V. Jaipur Zoo, Jaipur, Rajasthan

The Deputy Conservator of Forests, Mrs. Akansha Chowdhary did presentation and following were decided:-

2. Revised design of Hog deer, Sambar, Hyena and Spotted deer

SAMBHAR ENCLOSURE

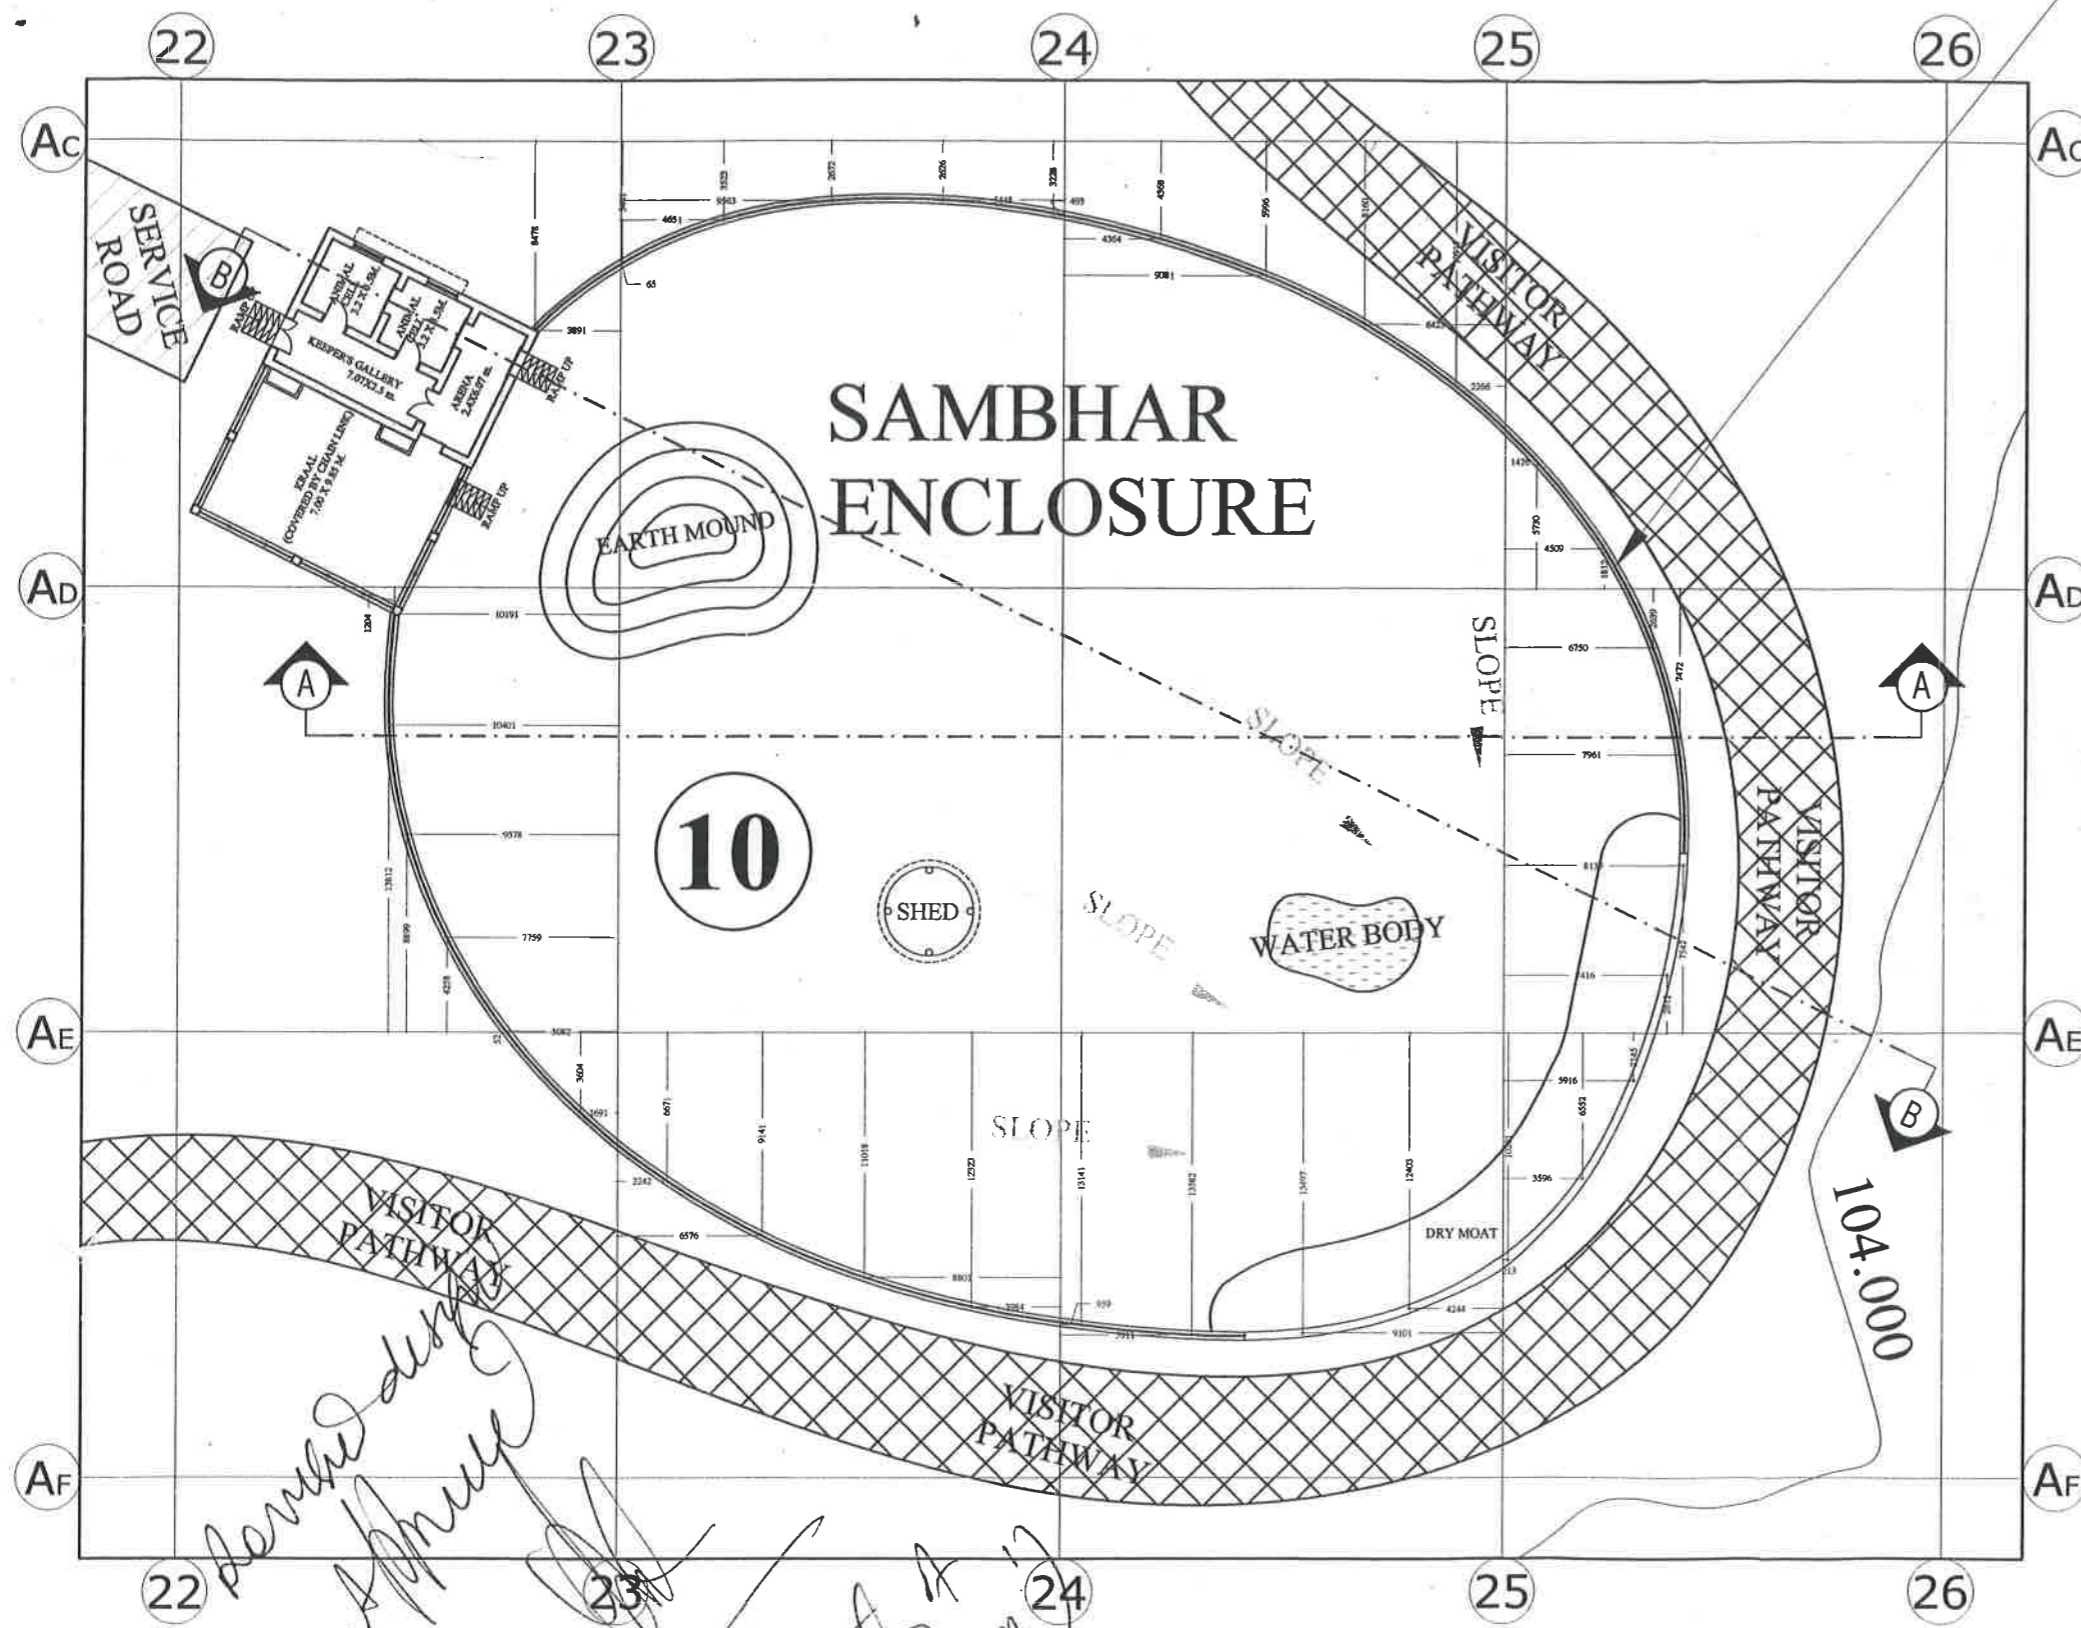
The designs were approved subject to that the moat depth should be kept 2.25 meter only.
